**RE: MODIFICATION TO PROJECT APPROVAL S07/00079**

As discussed with your Mr Ben Holmes on 25 July 2007, Macquarie Generation seeks to obtain approval for several modifications to the above project under Section 75W of the Environmental Assessment and Planning Act 1979. The modifications requested and the reasons for the changes are described below.

**Appendix A: Pipeline Study Area Showing New Location of the Discharge  
Structure and Location of Surge Tanks (Figure 2.2)**

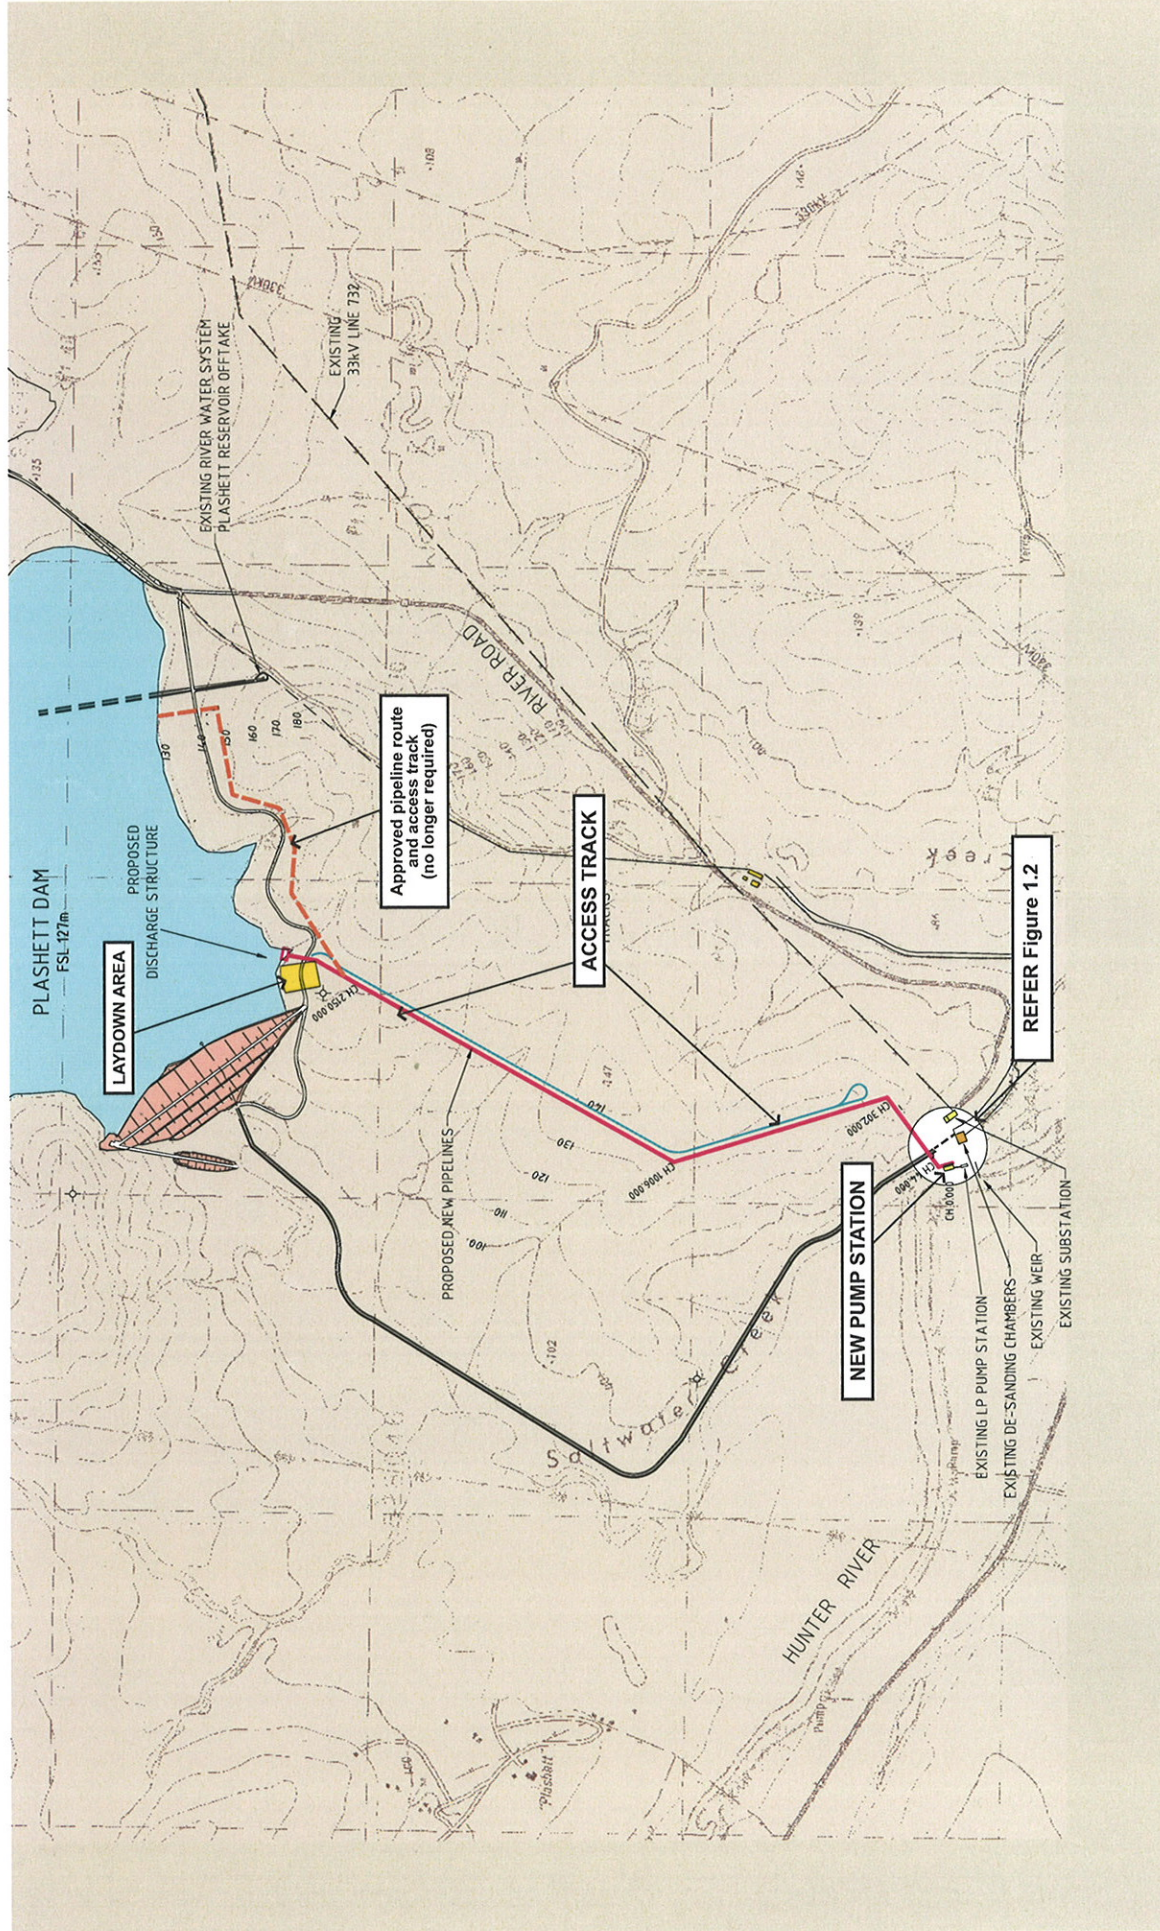
Following a design review, Macquarie Generation proposes to shorten the pipeline by one kilometre, by terminating the pipeline at the point at which it meets the shore of Plashett Dam. This last section of the pipeline was to run along the shore of the dam to the existing outlet point for discharge. The change in the pipeline route is shown in **Appendix A**.

Following the design review, Macquarie Generation's designers determined that the construction of additional surge mitigation infrastructure is necessary to prevent large pressures being generated due to the effects of water hammer. Therefore, two surge mitigation tanks are to be constructed up gradient of the inlet at the Hunter River. The locations of the additional surge tanks are shown in **Appendix A**.

**Figure**  
Plashett - Revised Outlet Arrangement

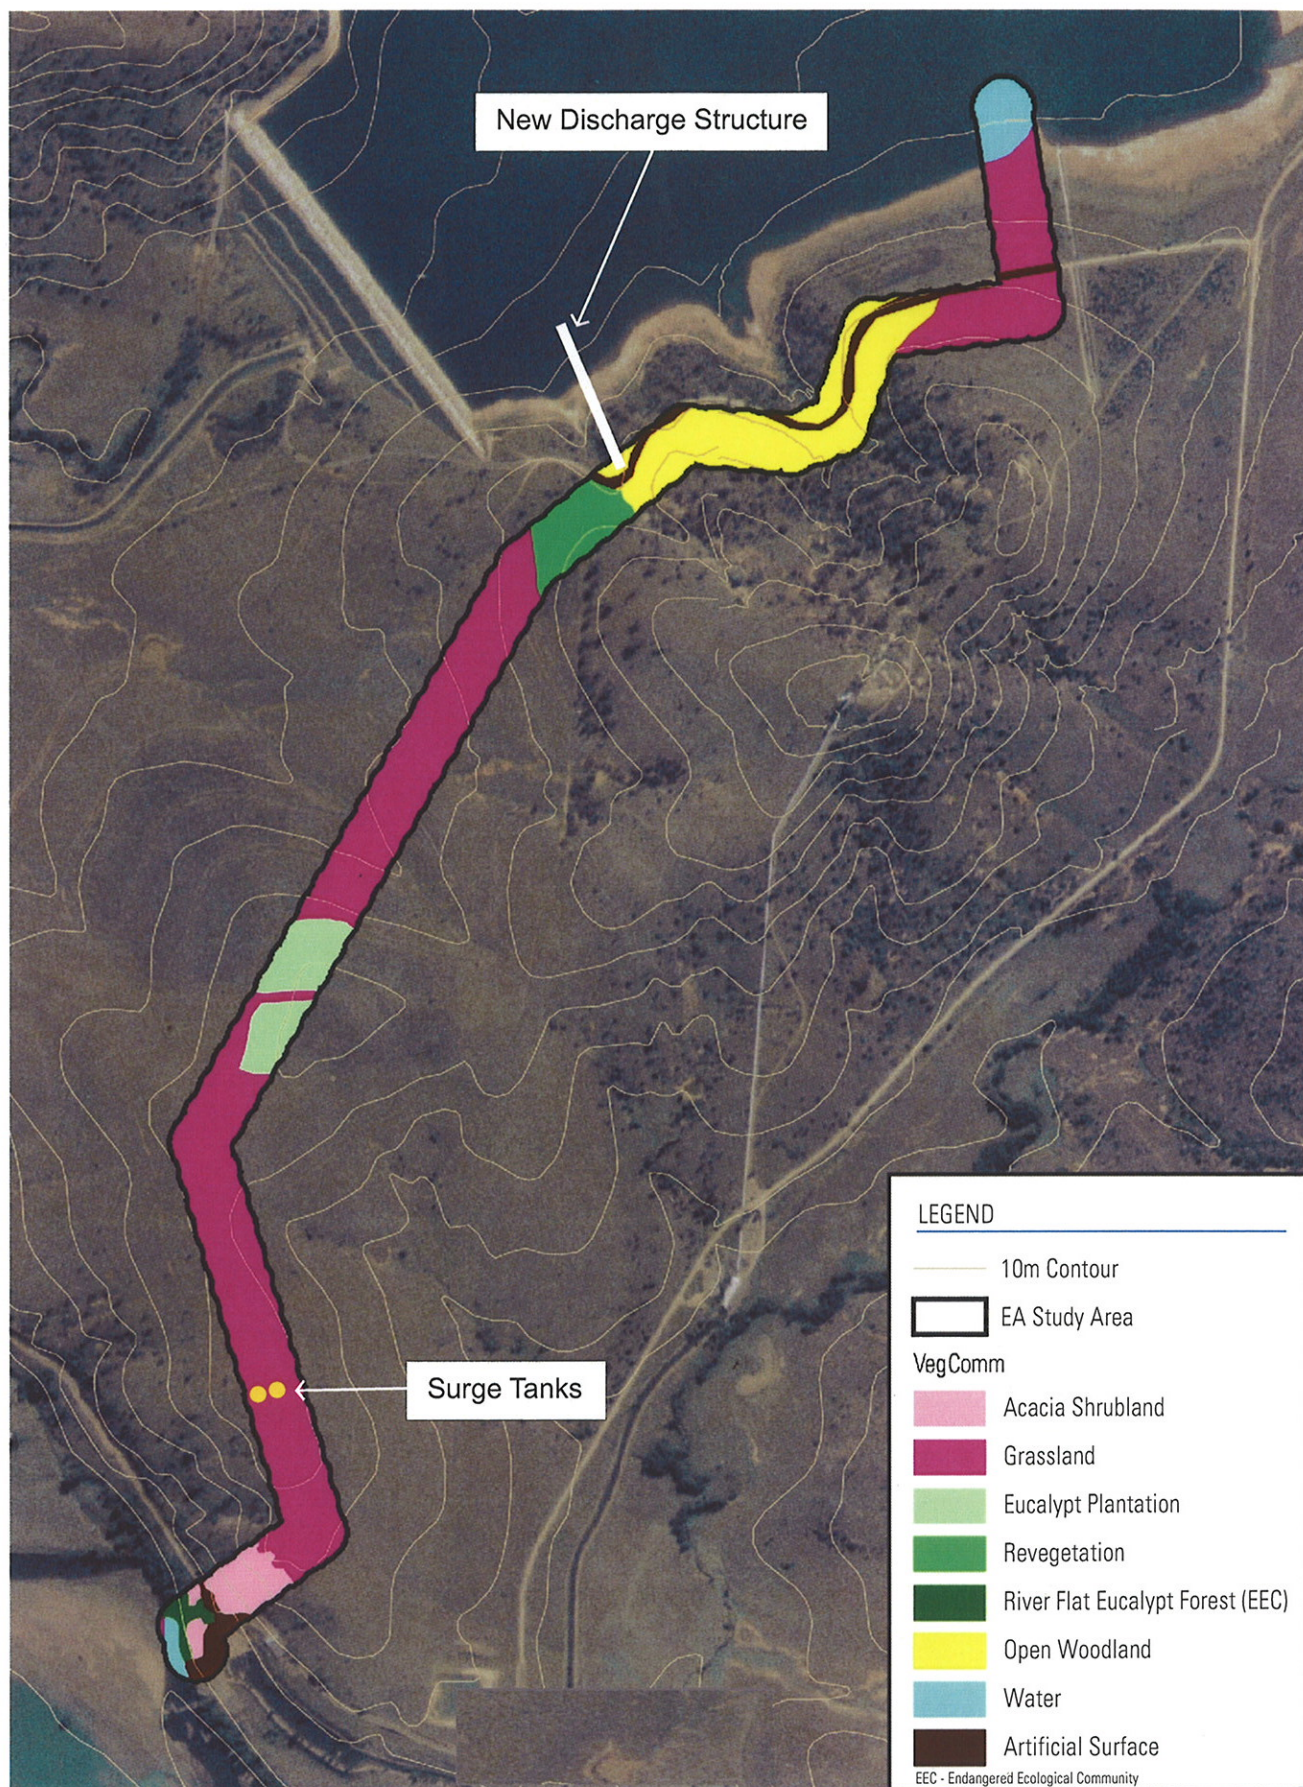
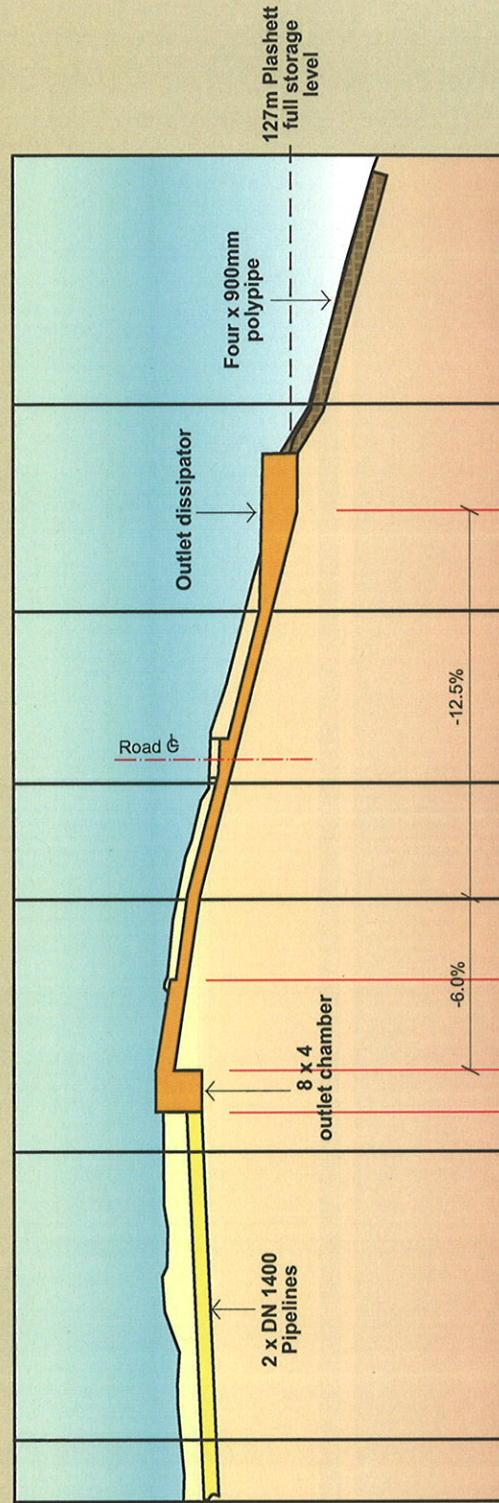
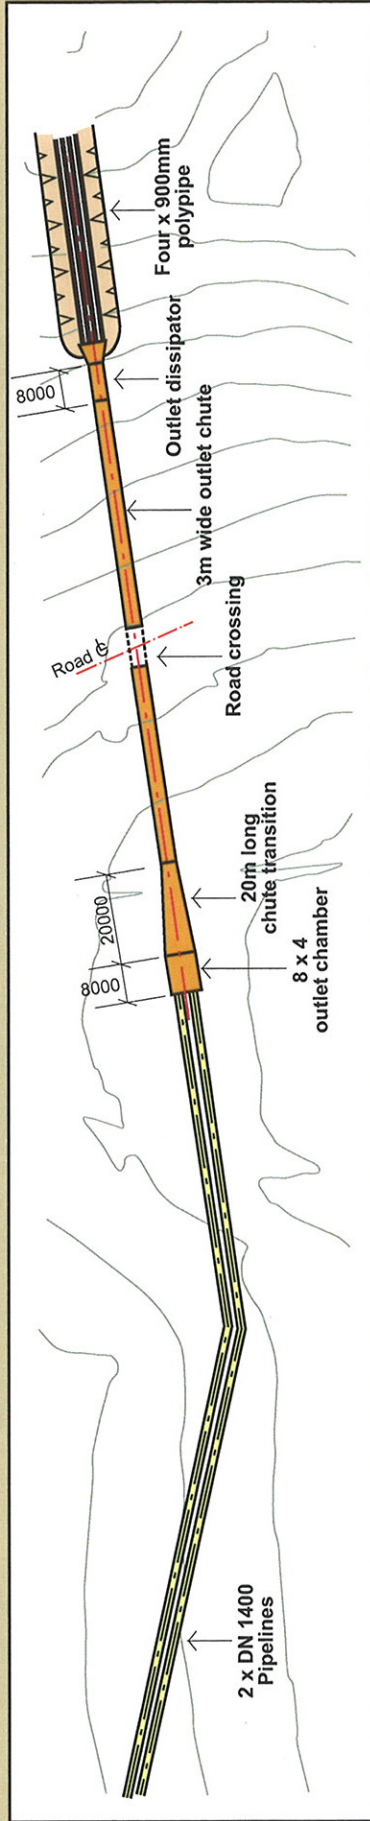
To ensure that the operation of the Plashett Dam would not be affected by the proposed change to the location of the outlet structure, Macquarie Generation consulted Ian Forster from Connell Wagner, who specialises in dams and dam safety. Ian's advice is quoted below:

*"Based on the latest proposal, the location and concept design of the discharge pipeline and inlet structure should pose no problems for the normal operation of Plashett Dam. The structure will be located at a sufficient distance from the dam wall that it will not influence the stability of the wall, and the design of the structure will minimise the potential for any erosion on the left abutment. Since the structure has no impact on the overall safety of the dam, there will be no need to seek the approval of the NSW Dams Safety Committee".*
